City of Spokane

Joint Arts Committee Meeting

9 a.m. Wednesday, Dec. 20, 2017

- A. [Potential signature art locations](#) – *Melissa Huggins* reviewed Meejin Yoon's eight suggested sites for the signature art piece. Site #1, near the Conservation Area, and site #2, across from the Bosch Lot near the Footsteps to the Future statue, are proposed for the Earth Ring. Sites #3 - #8 were suggested as potential sites for Step Well. Since Earth Ring is designed for river and fall views, there are limited locations for optimal riverfront viewing. However, the committee felt some of the proposed sites for Step Well could be eliminated for consideration. The group discussed the pros and cons of placing a large art piece in the heart of the park near areas designed for large events. Following deliberation, the committee agreed the open space areas designated for events are not the best choices for Step Well. The group also shared opinions on placing art too far away from parking or on the outskirts of the park. Ms. Huggins will take the committee's recommendations back to Ms. Yoon.

POTENTIAL STEP WELL SITES

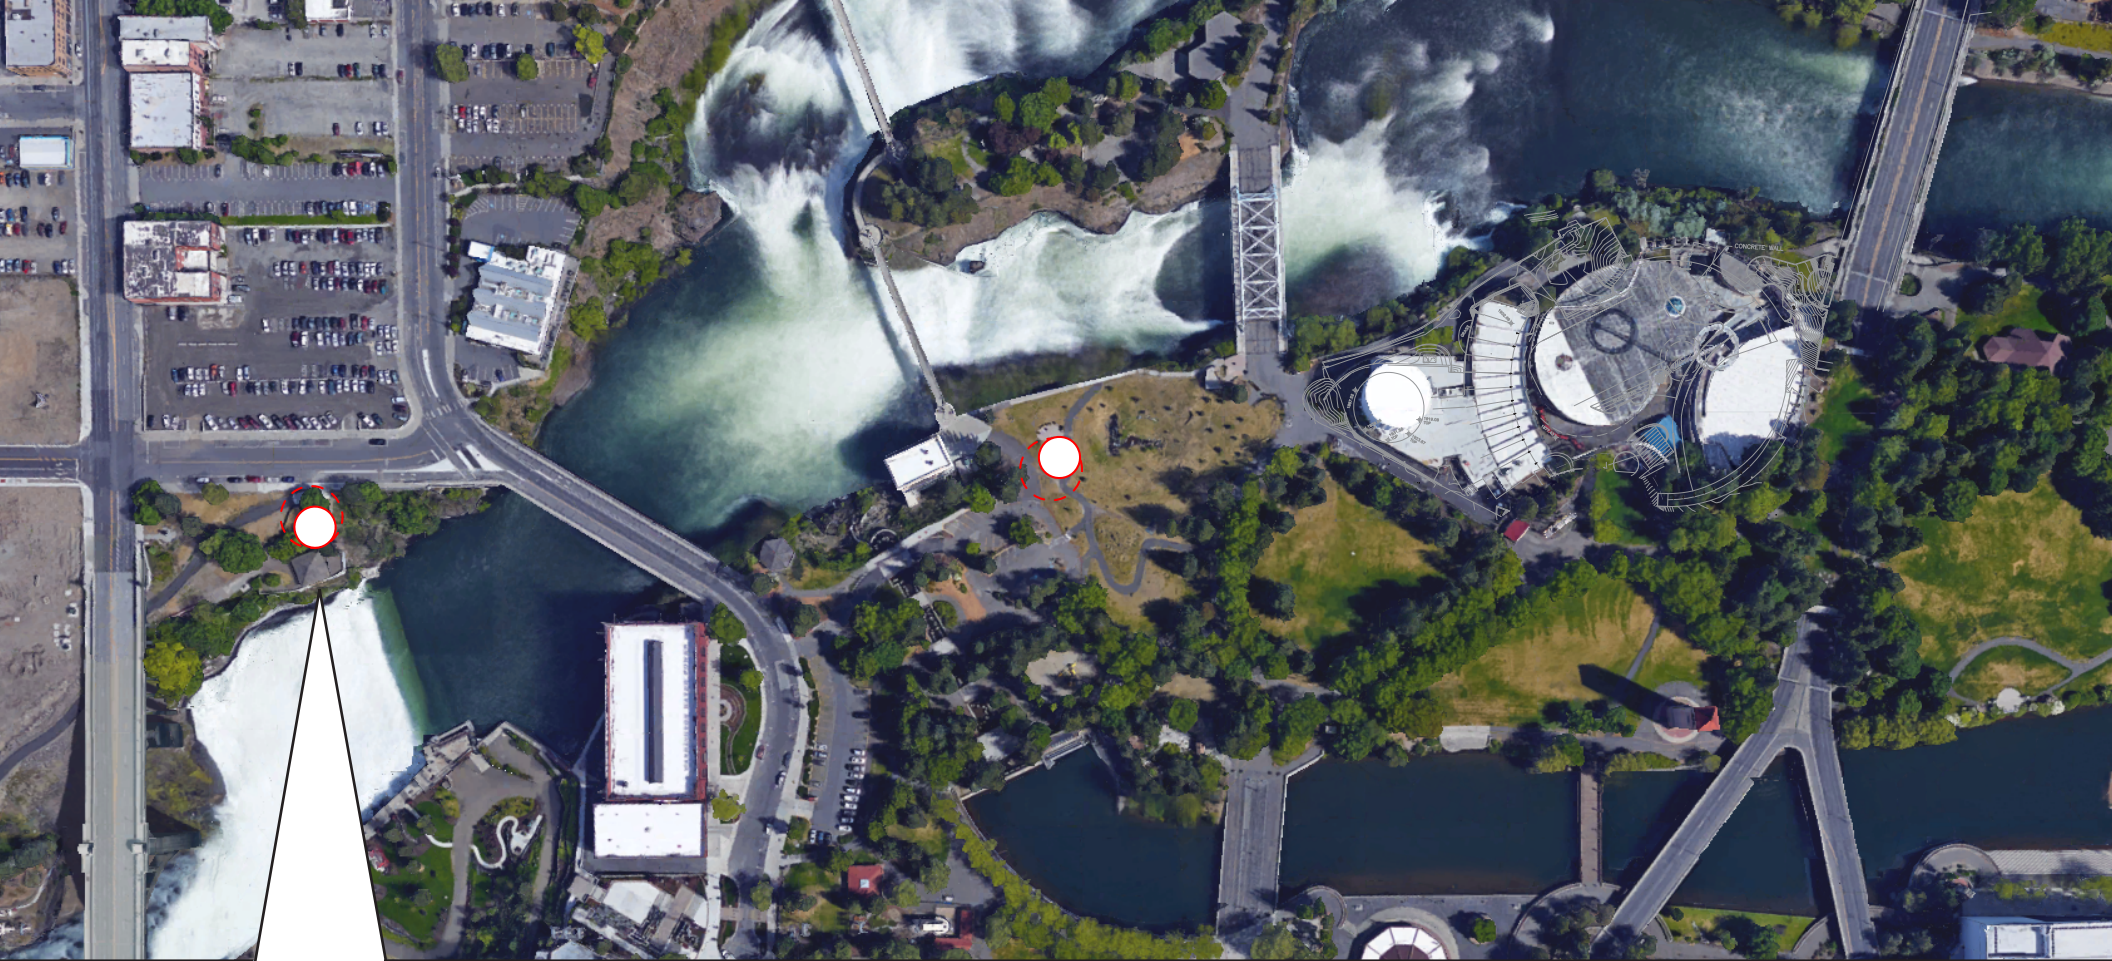
Committee recommendation: 1) Earth Ring: Committee prefers Site #2 for Earth Ring, but Site #1 remains on the table for consideration. 2) Step Well: Committee agreed to remove Sites #4, #6 and #7 for consideration.

SCALE - SEAT COUNT

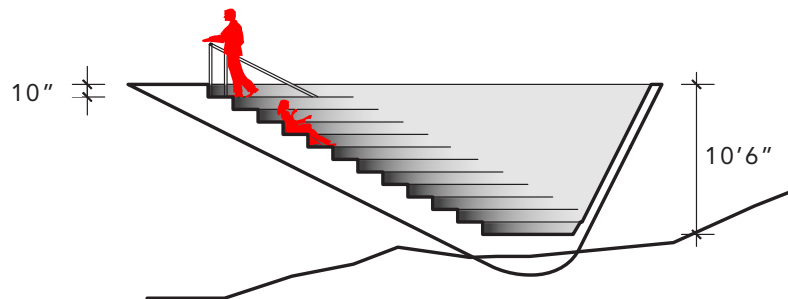
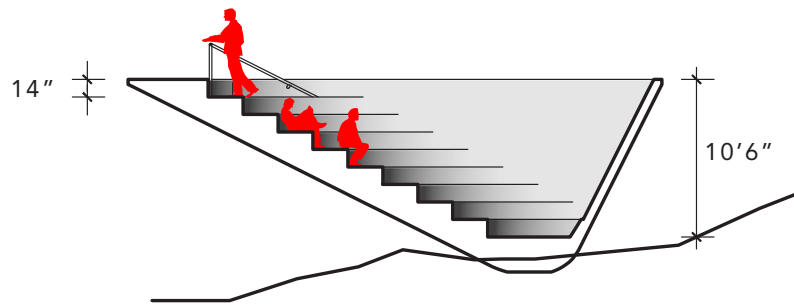
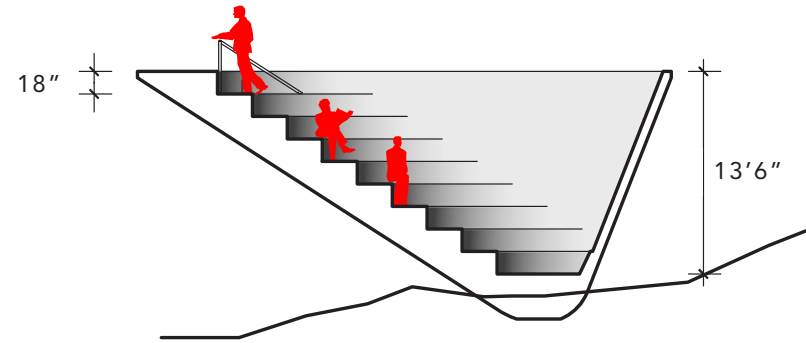
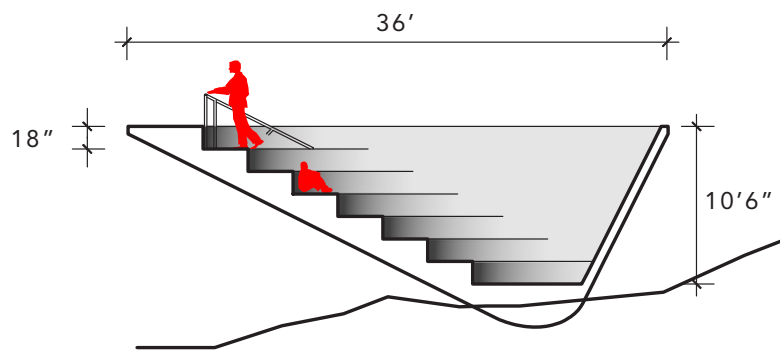
- b. **Step Well** – Four options were presented ranging from 51' width x 36' height (165 seats) to 30' width x 21' height (80 seats). The committee preferred the 42'6" x 30' scale.

EARTH RING

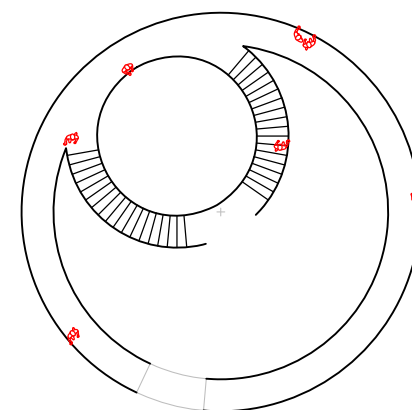
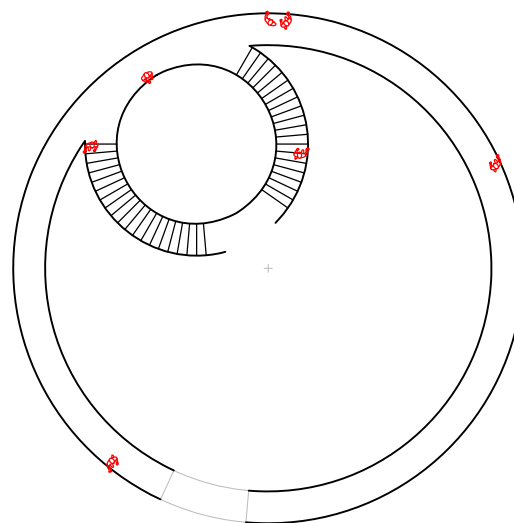
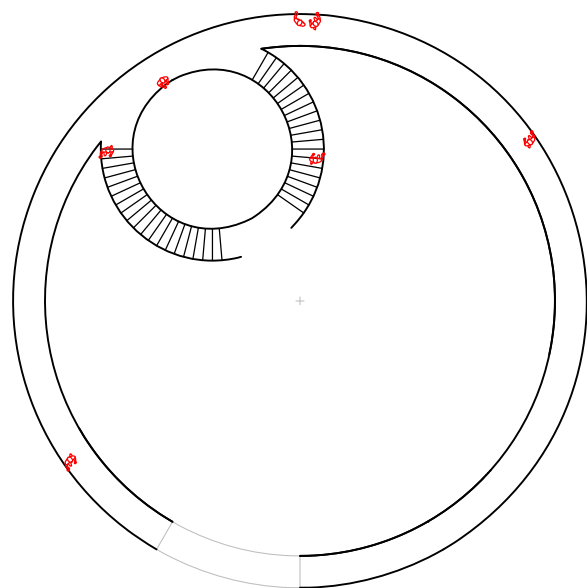
- a. **Earth Ring** – Three options were presented, including the original 72-foot diameter, 64-foot diameter and 50-foot diameter. The committee the site may dictate how large the ring can be. The committee agreed the 50-foot diameter would be fine, but would like more information on how it fits on the two sites.
